**MEETING AGENDA
SESSION OF THE HISTORIC PRESERVATION BOARD
CITY OF KISSIMMEE
CITY HALL, COMMISSION CHAMBERS
101 CHURCH STREET, KISSIMMEE, FLORIDA 34741-5054
MONDAY, SEPTEMBER 14, 2026 AT 5:15 PM**

COA-26-0005 - 210 North Vernon Avenue (new construction)

NEW RESIDENCE AT
210 N. VERNON AVE.
KISSIMMEE, FL. 34741

REAR ELEVATION
SCALE: 1/4"=1'-0"

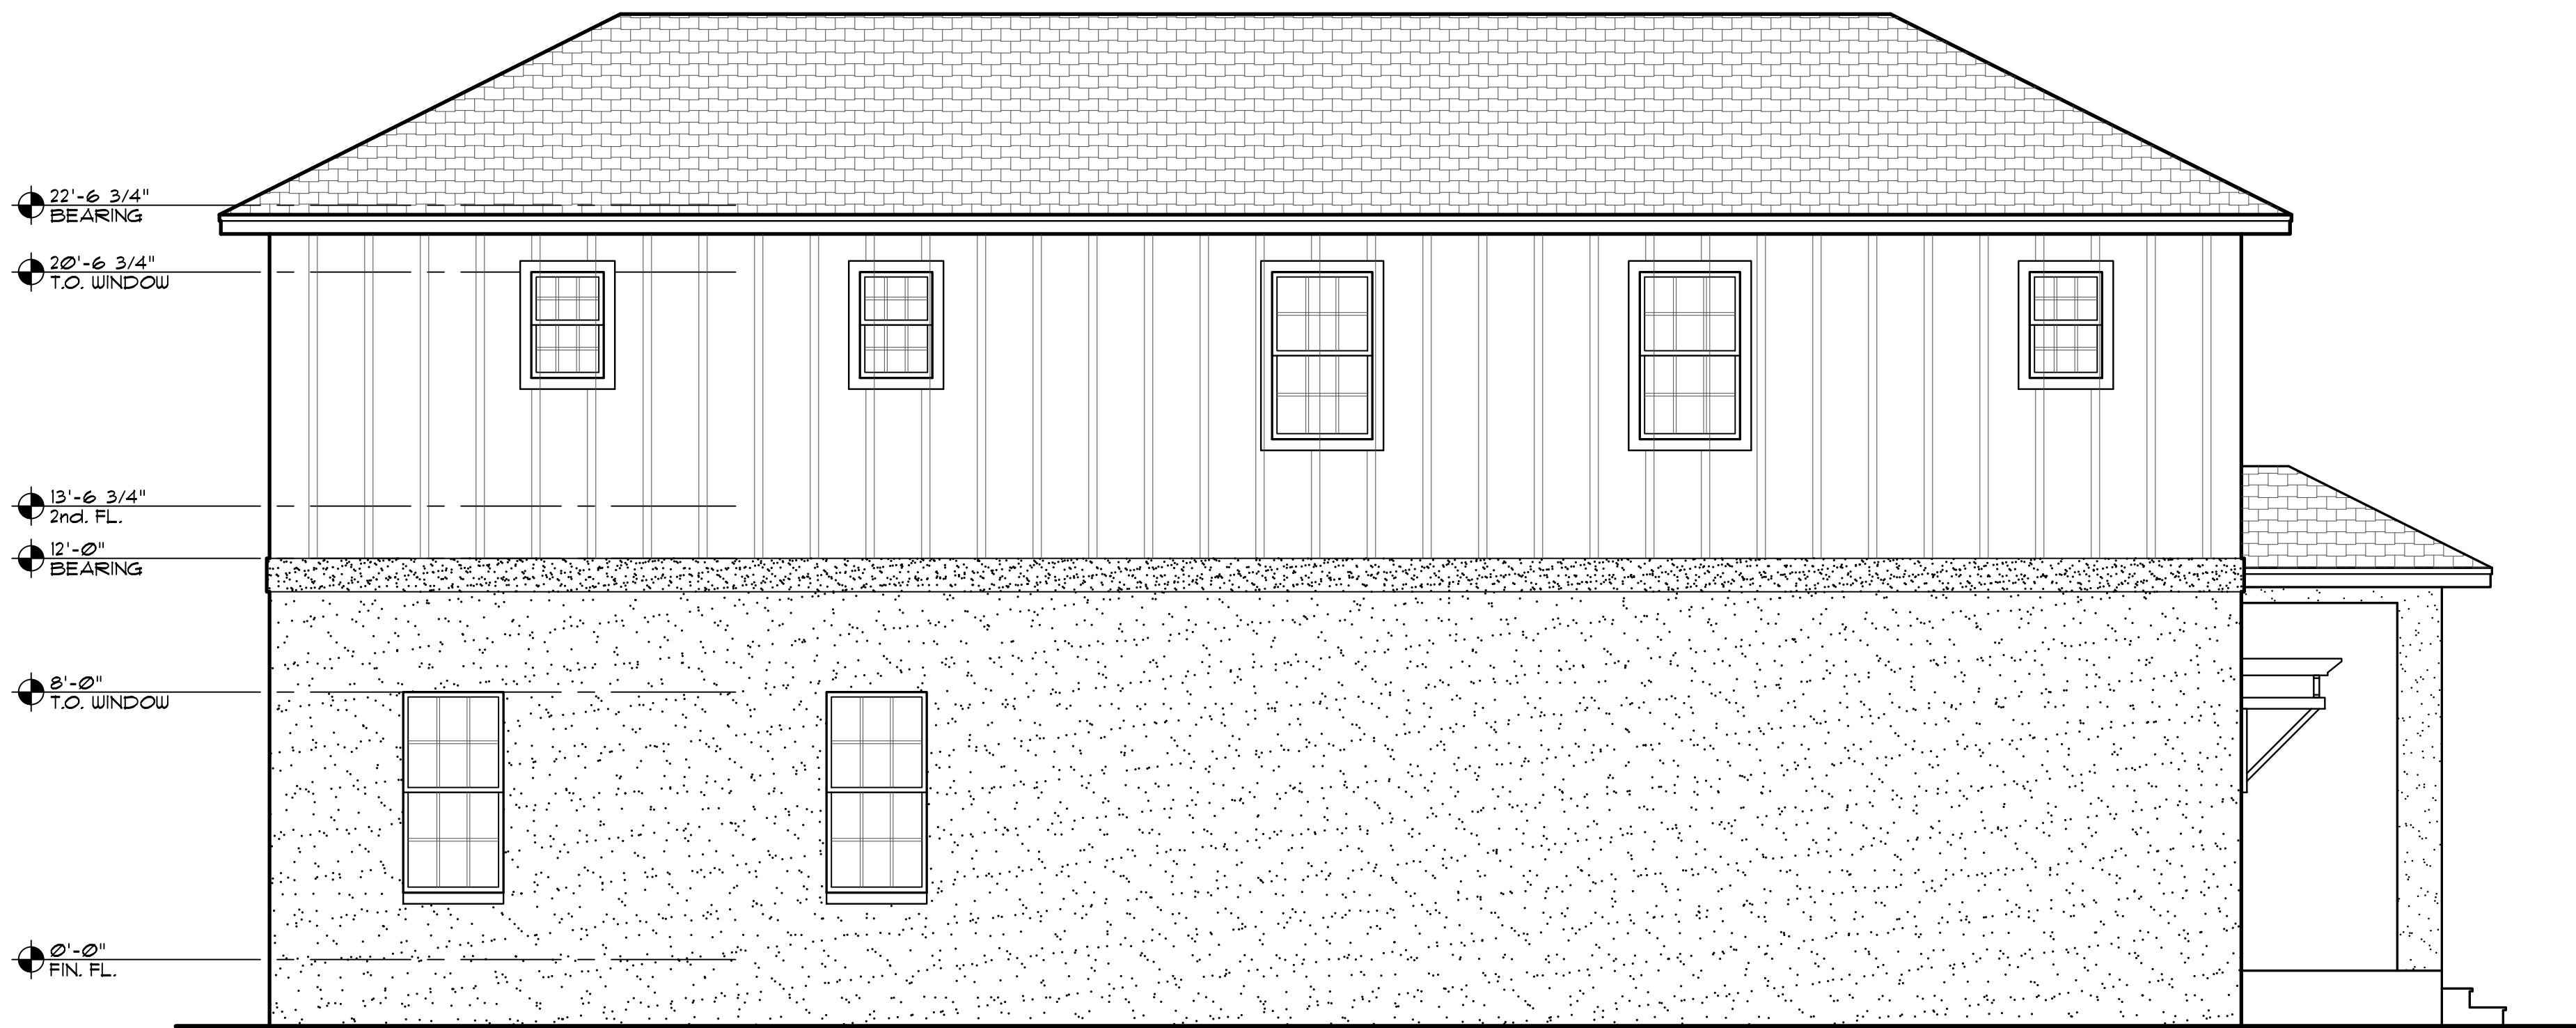
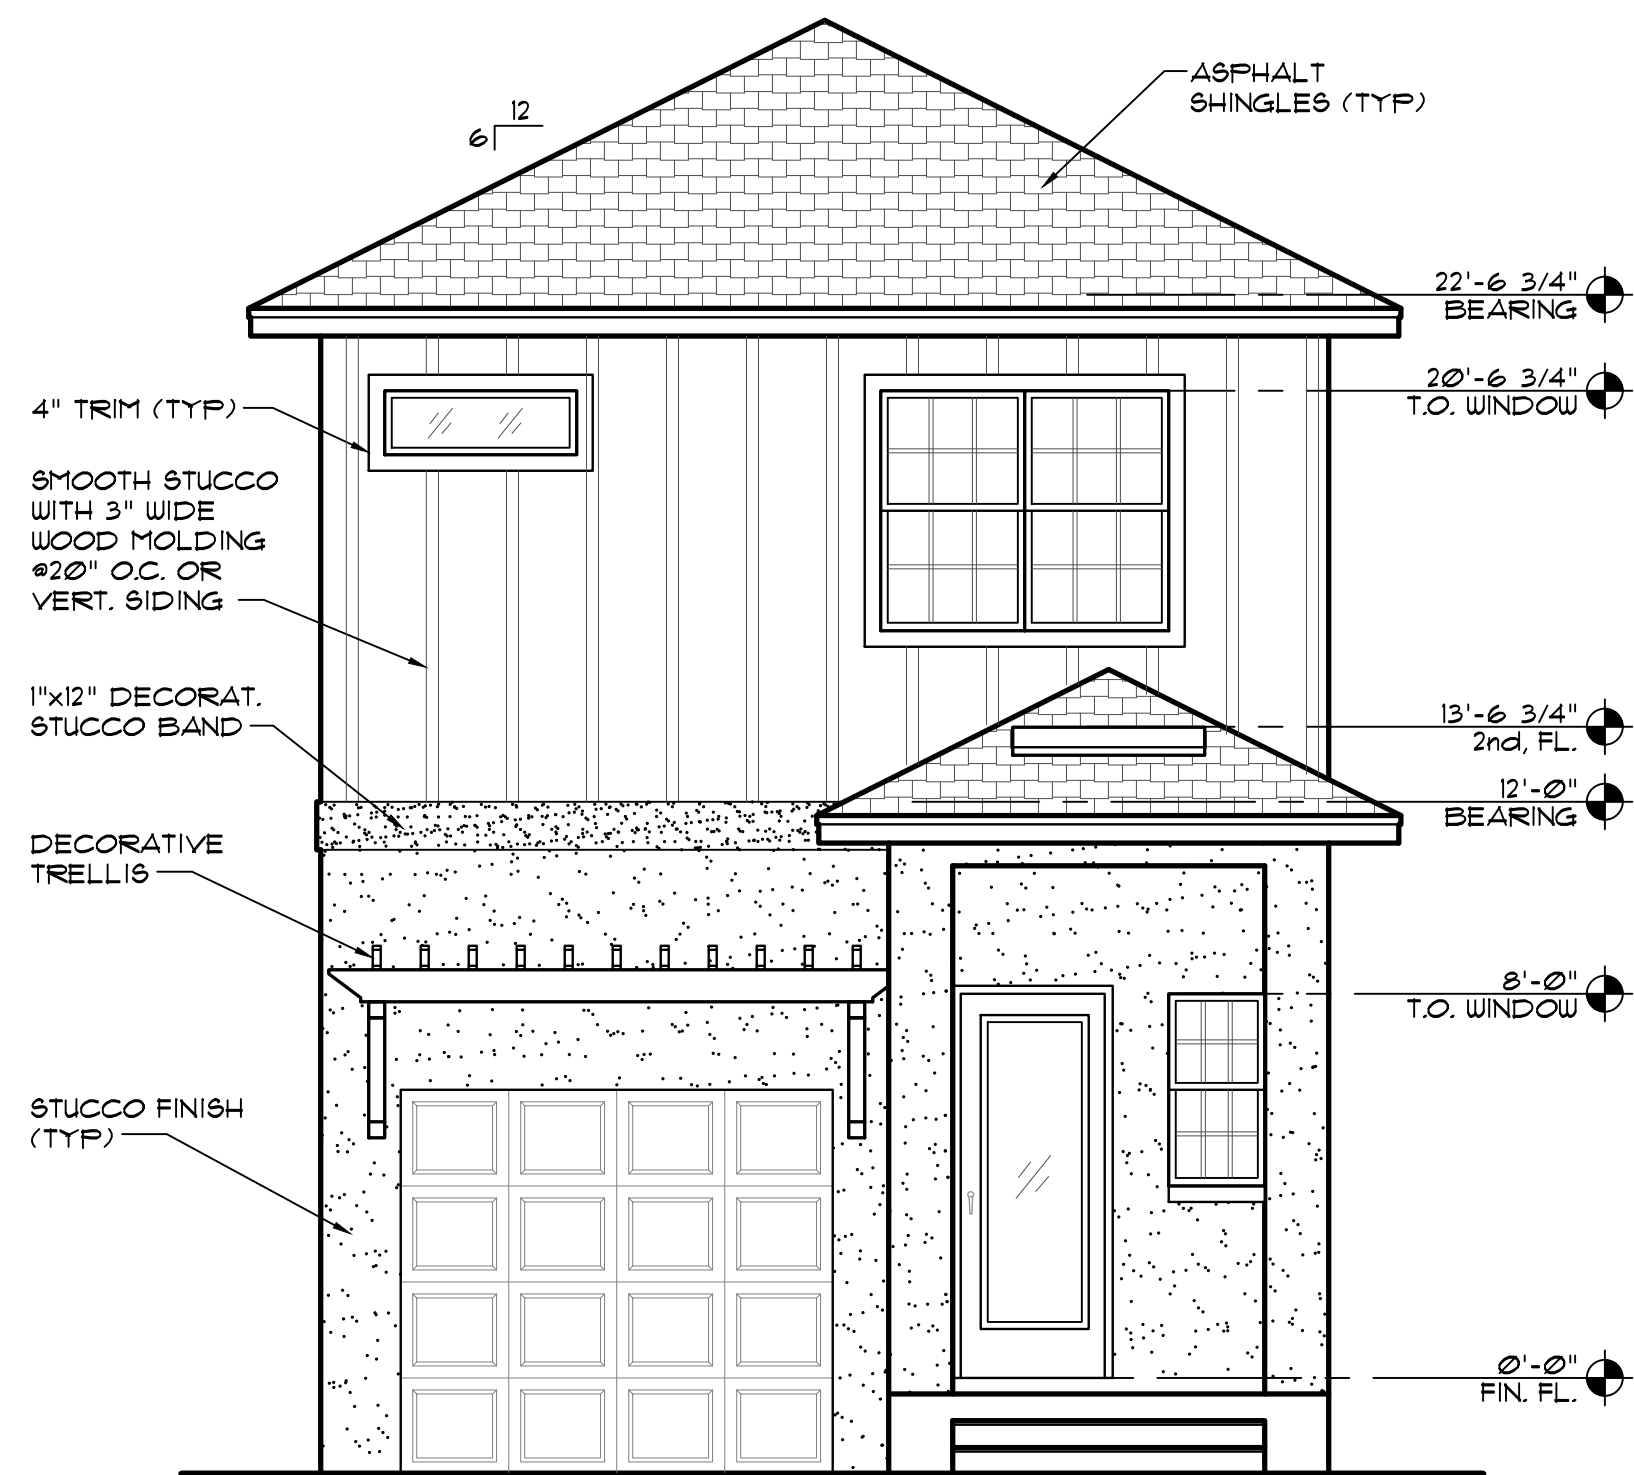
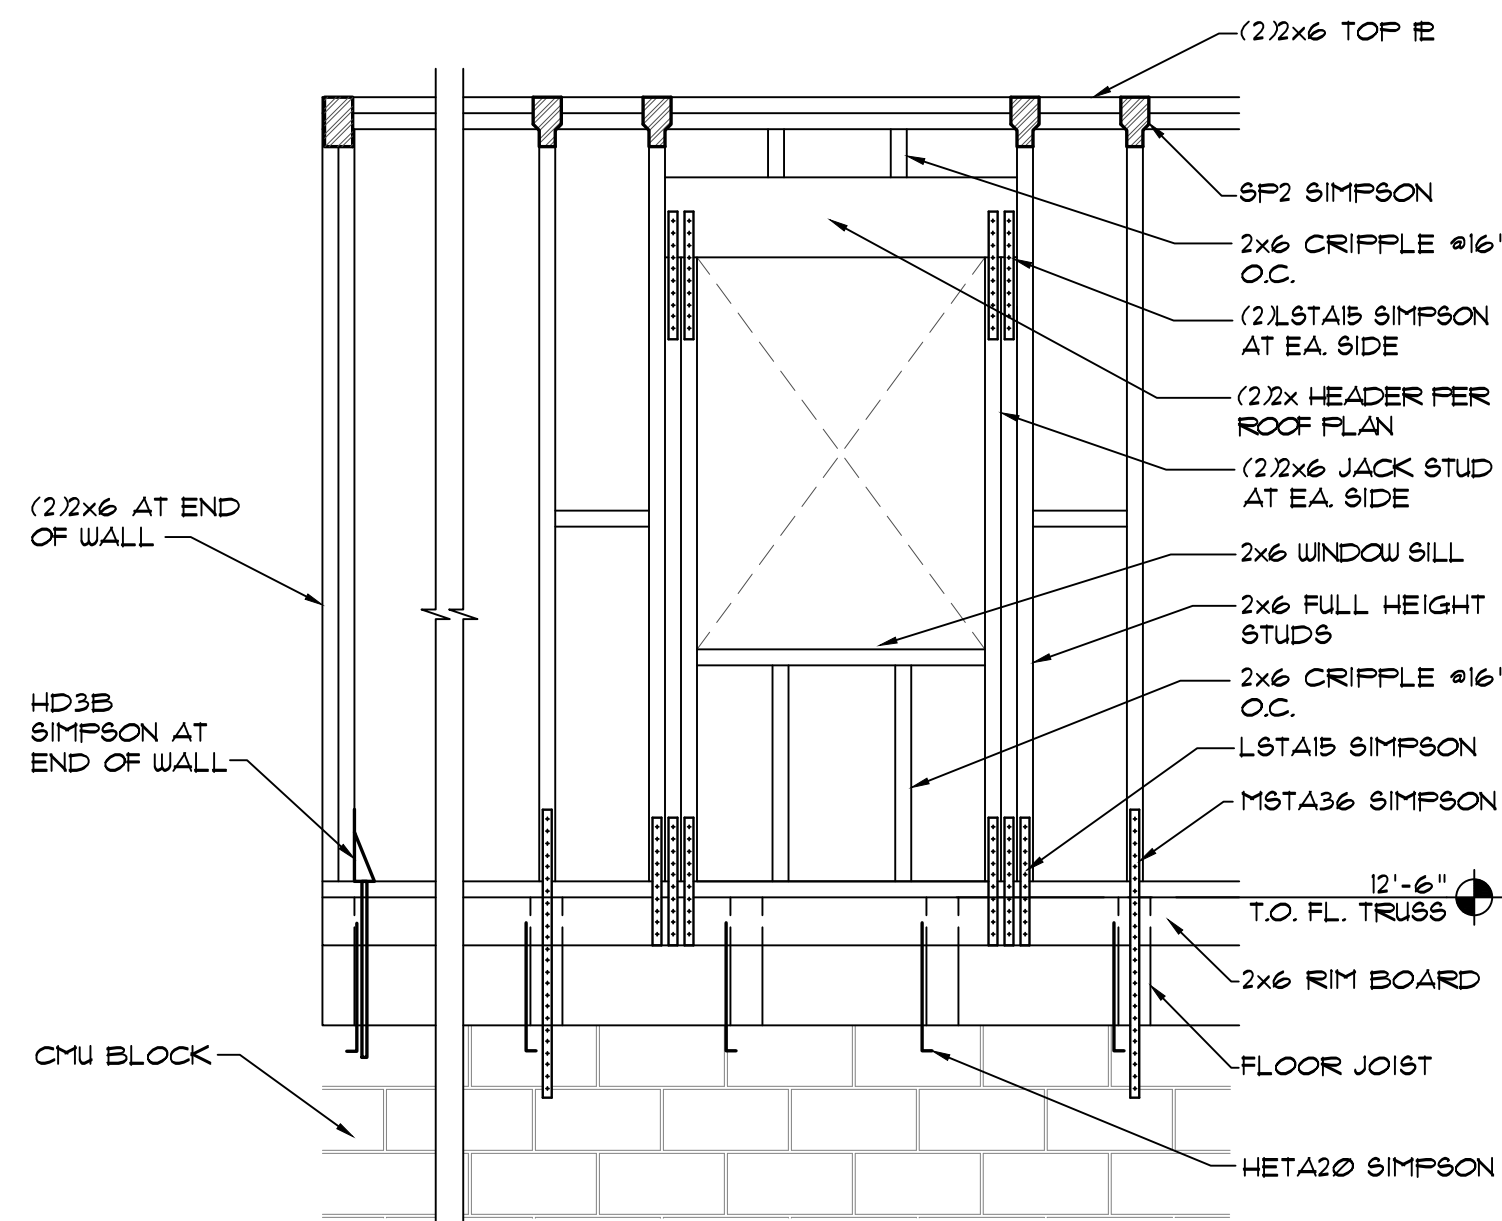
- Change the windows on the front elevation to those of similar size and symmetrical to the building.
- Add more windows on all sides to provide balance. This is particularly needed on the rear, left, and right elevations.
- Provide the 4" banding on all windows.
- Provide symmetrical windows (where possible). Symmetrical windows should be around the same size.
- Remove the garage.
- Maintain the elevated porch, but make it a prominent feature at the front of the structure.

- Since the lot is so narrow, making the structure long and narrow, it is recommended that some articulation be provided to break up the façade, particularly on the side elevations. This will provide some visual relief and can be used in conjunction with windows to provide visual relief.

FRONT ELEVATION
SCALE: 1/4"=1'-0"

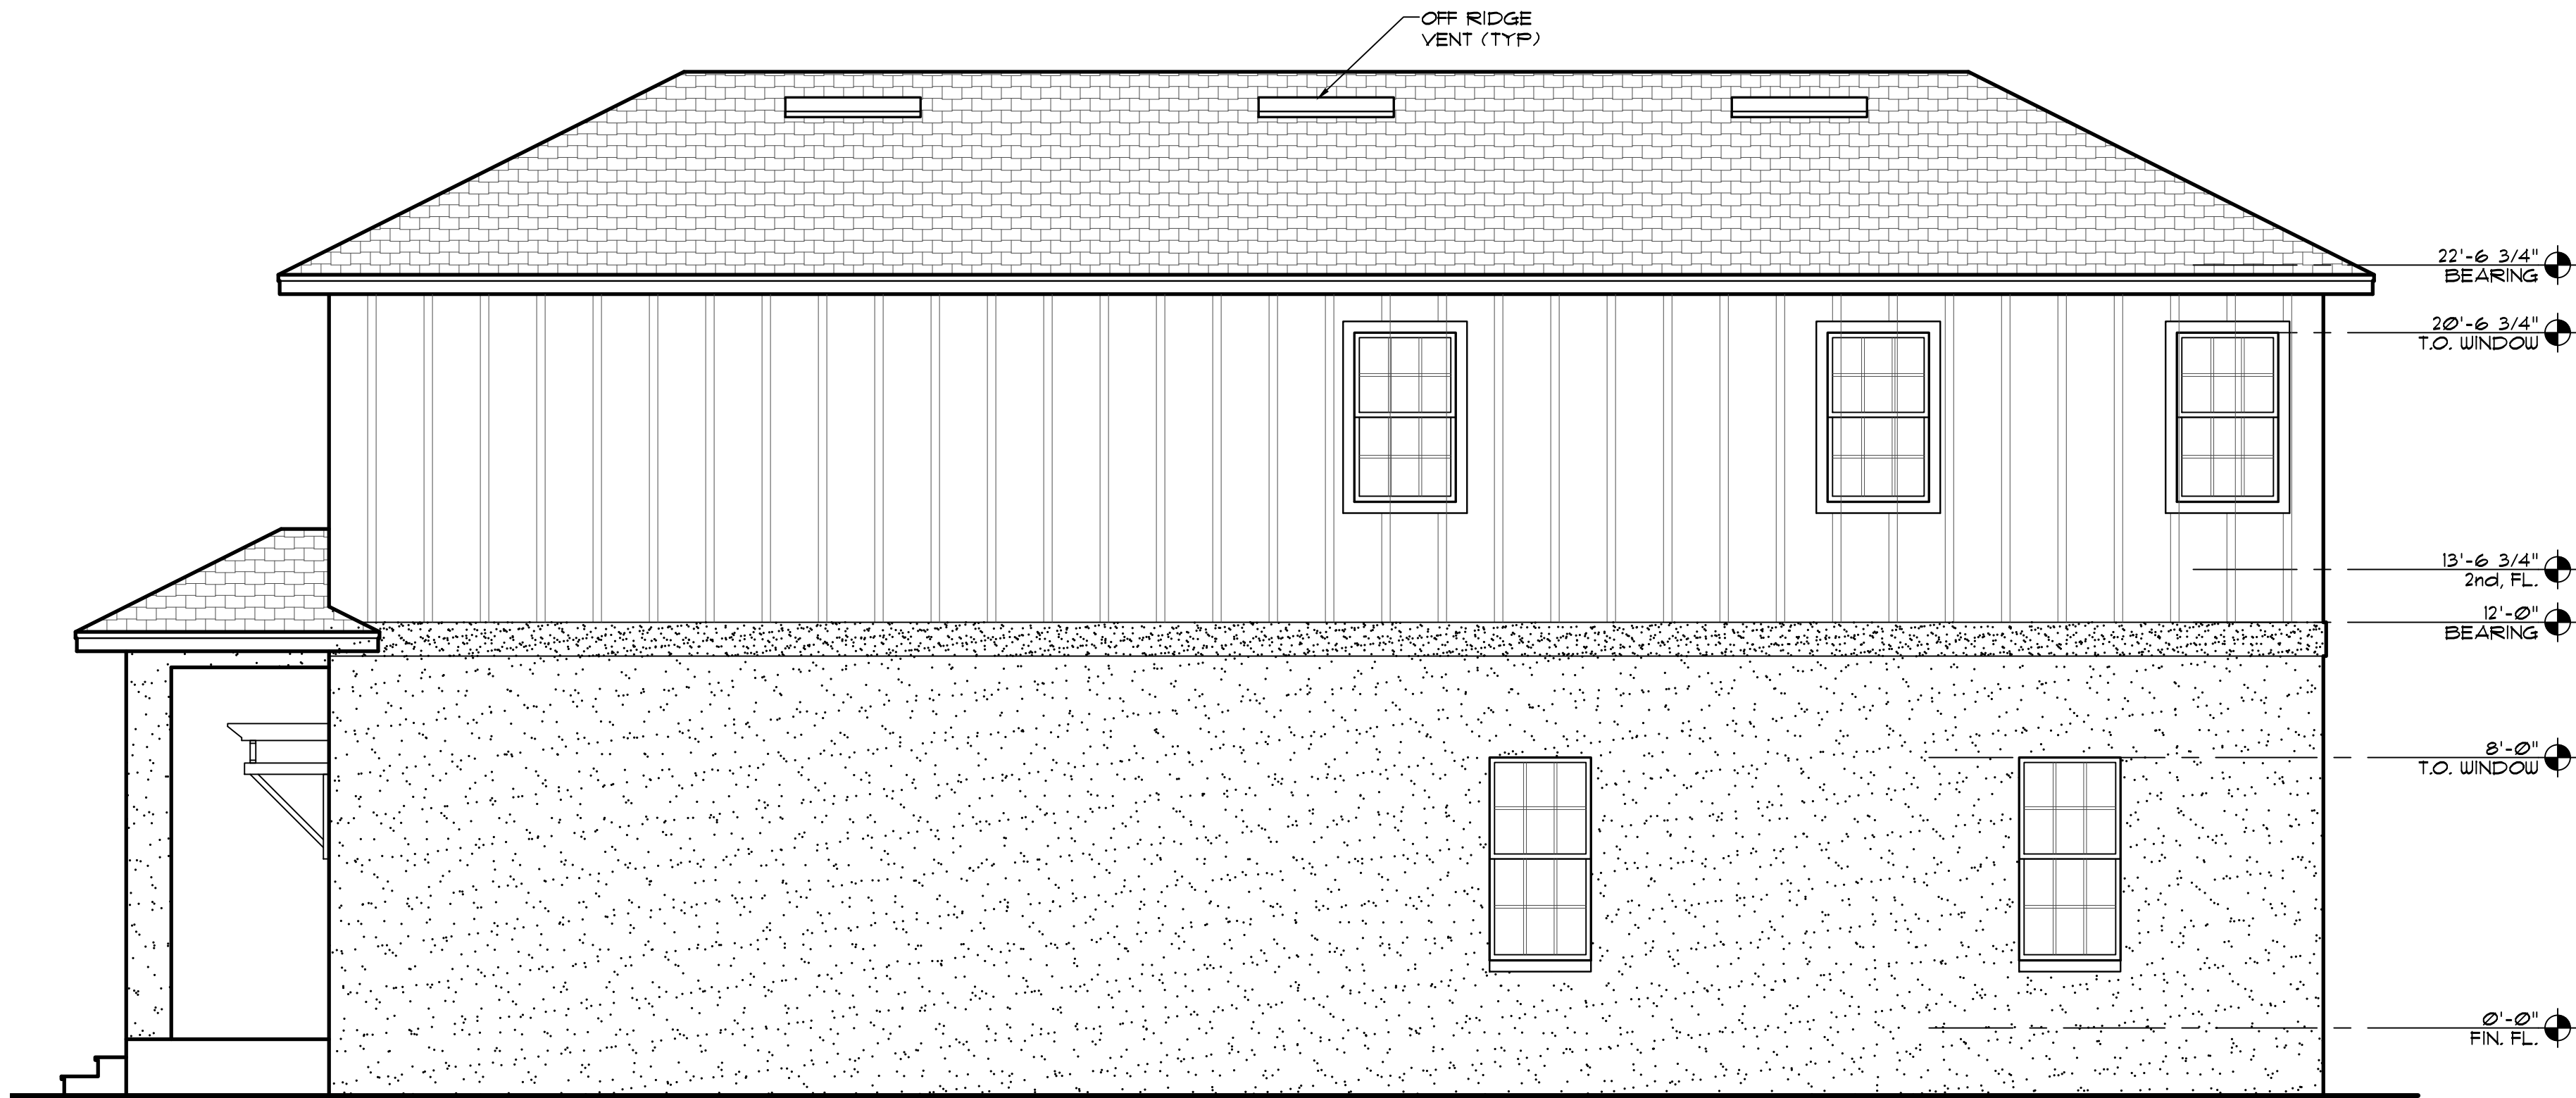
While the proposed garage is subordinate in floor area, it does dominate the primary façade of the structure and takes up approximately 56% of the frontage. The porch, which extends six feet from the main structure and whose opening is three feet smaller than the garage door, does not provide relief from the garage.

Additionally, the decorative trellis over the garage door (materials unknown) extends three feet from the front wall and brings more attention to the placement of the garage. While this may have been an effort to alleviate the prominence of the garage, it appears awkward on the frontage.

- Remove the garage.
- Remove the decorative trellis over the garage.
